HDI PNP 2023-030

Palisades Nuclear Plant  
NRC Docket No. 50-255  
Renewed Facility Operating License No. DPR-20

**Subject:** License Amendment Request to Revise Renewed Facility Operating License and Permanently Defueled Technical Specifications to Support Resumption of Power Operations

Figure 3.4.3-1 (Page 1 of 1)  
Pressure – Temperature Limits for Heatups  
Applicable up to 42.1 EFPY

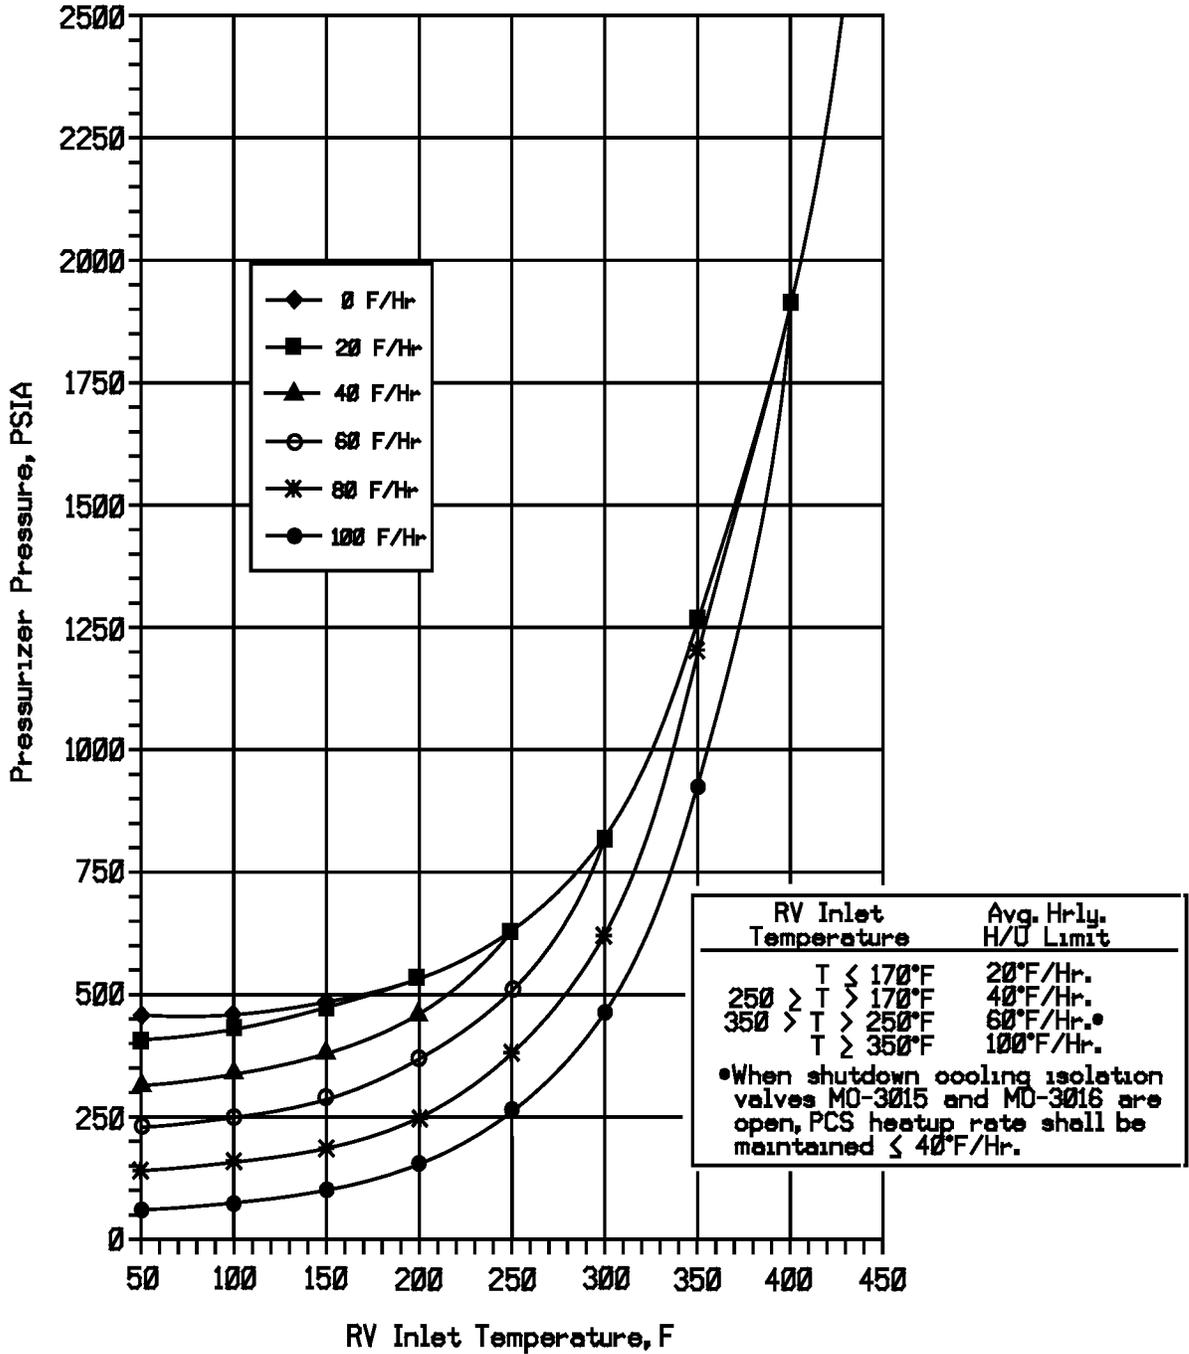
LCO 3.4.3 PCS pressure, PCS temperature, and PCS heatup and cooldown rates shall be maintained within the limits of Figure 3.4.3-1 and Figure 3.4.3-2.

Figure 3.4.12-1 (Page 1 of 1)  
LTOP Setpoint Limit  
Applicable up to 42.1 EFPY

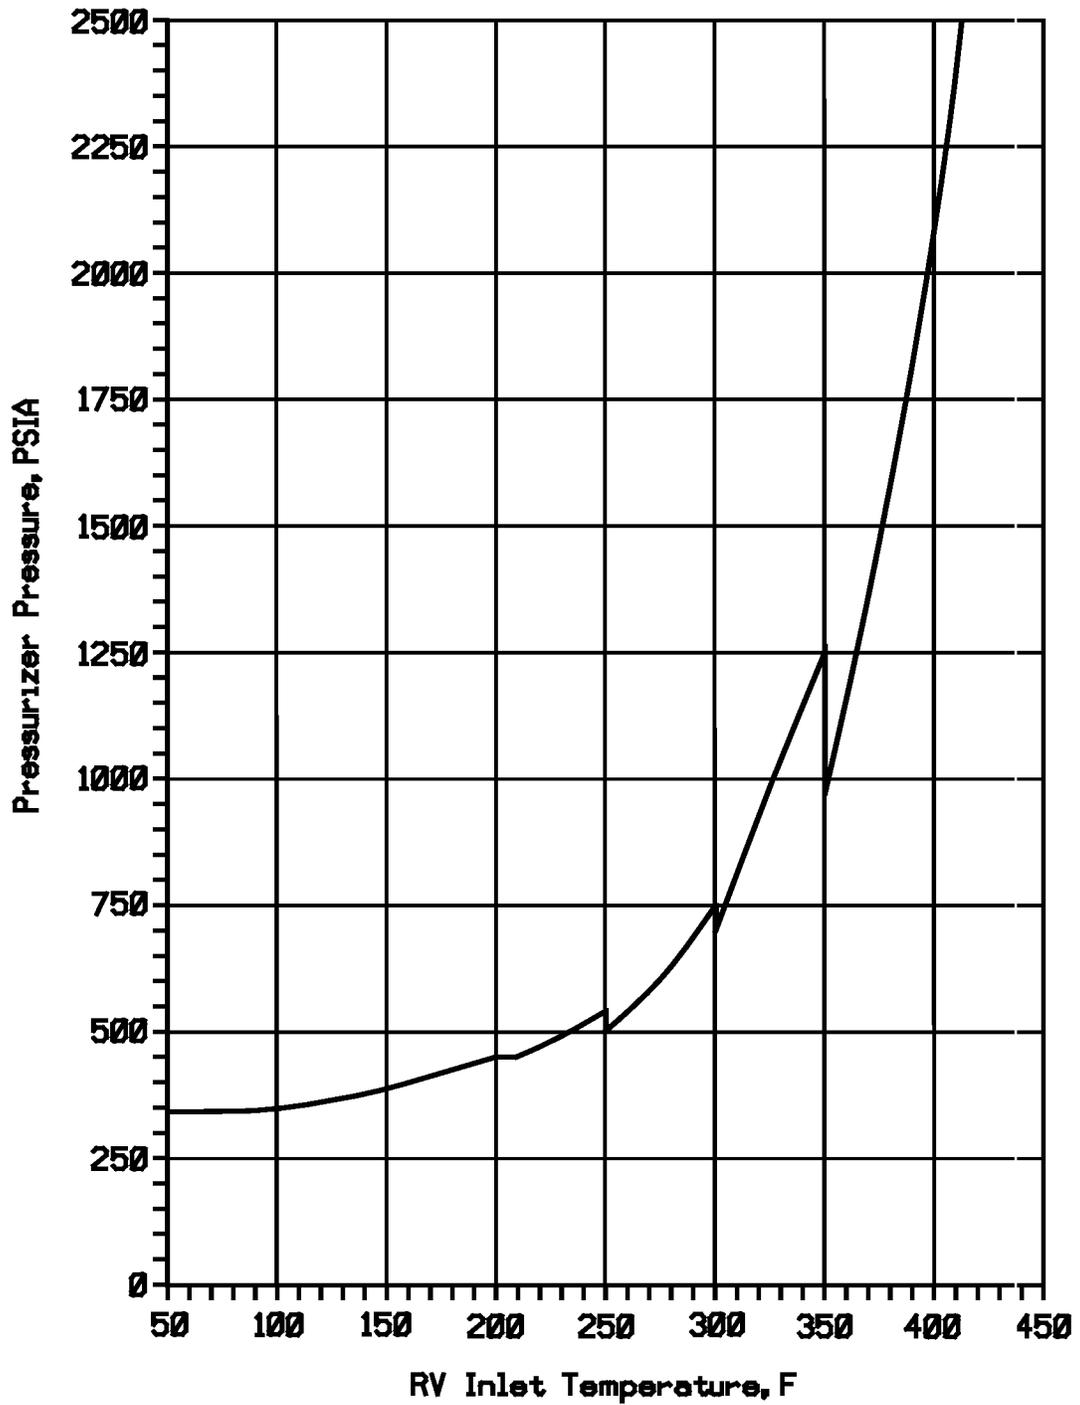
- 1. Two Power Operated Relief Valves (PORVs) with lift settings as specified in Figure 3.4.12-1; or
- 2. The PCS depressurized and a PCS vent capable of relieving ≥ 167 gpm at a pressure of 315 psia.

Figure 4.3-1 (page 1 of 1)  
New Fuel Storage Rack Arrangement

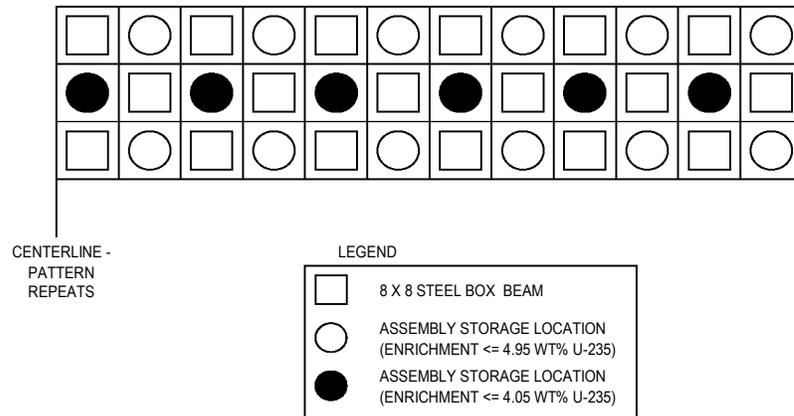
- a. Twenty four unirradiated fuel assemblies having a maximum nominal planar average U-235 enrichment of 4.95 weight percent, and stored in accordance with the pattern shown in Figure 4.3-1, or

Thirty six unirradiated fuel assemblies having a maximum nominal planar average U-235 enrichment of 4.05 weight percent, and stored in accordance with the pattern shown in Figure 4.3-1;
